January 13, 2015

Re: Design Progression – Final UDC
3204 Golden Copper Lane
Maple Grove Commons
Madison, WI
KBA Project #1355

Re: Letter of Intent – Final UDC Application
Maple Grove Commons
Madison, WI
KBA Project # 1355

3204 & 3228 Golder
Copper Ln.
Madison, WI
SHEET TITLE
Exterior Elevations - Building A

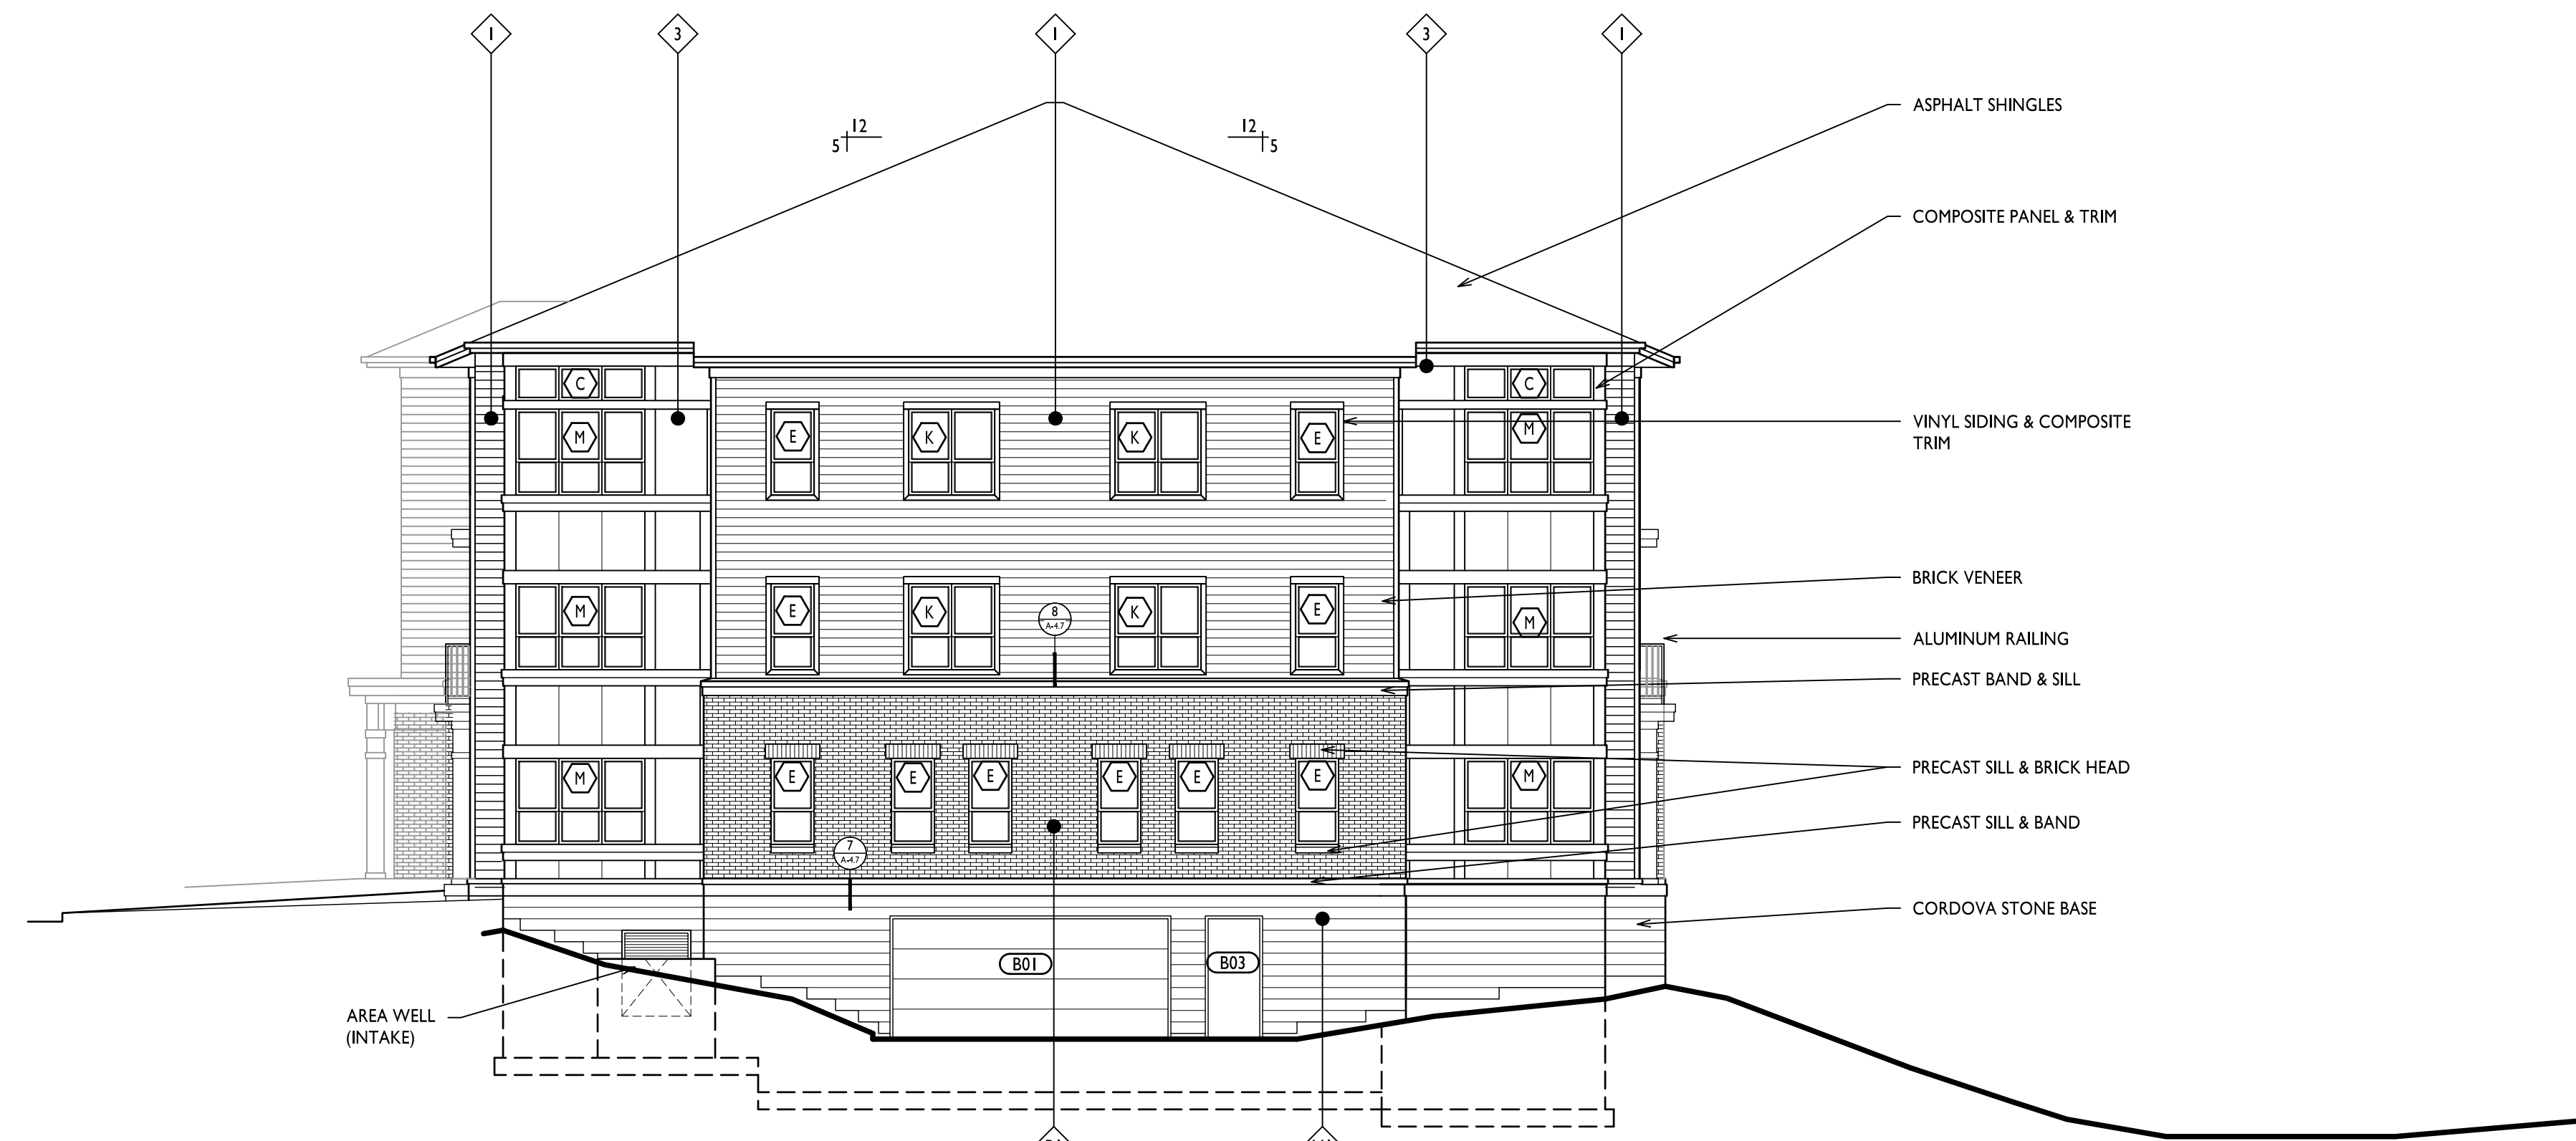
- The amount of brick veneer has been reduced.
- The concrete plaza adjacent to the community room at 3228 Golden Copper Lane has been removed (A-2.3 & A-2.4, West & South Elevation, Building B).

- Window patterns on the second floor have been modified to match the window patterns on the third floor.
- The balcony railings have been modified from a double top rail with vertical pickets to a single top rail with vertical pickets.
- Roof overhangs have been reduced from 36" to 24".
- Four of the first floor patio doors have been replaced with sliding patio doors (A-2.3, North Elevation, Building B)
- The quad windows on the corner bay have been modified to tripe windows on the North & East elevations of Building A.
- All composite arch trim above the first floor patios was removed except at the main building entries.
- The HVAC penetrations at the new locations are shown.
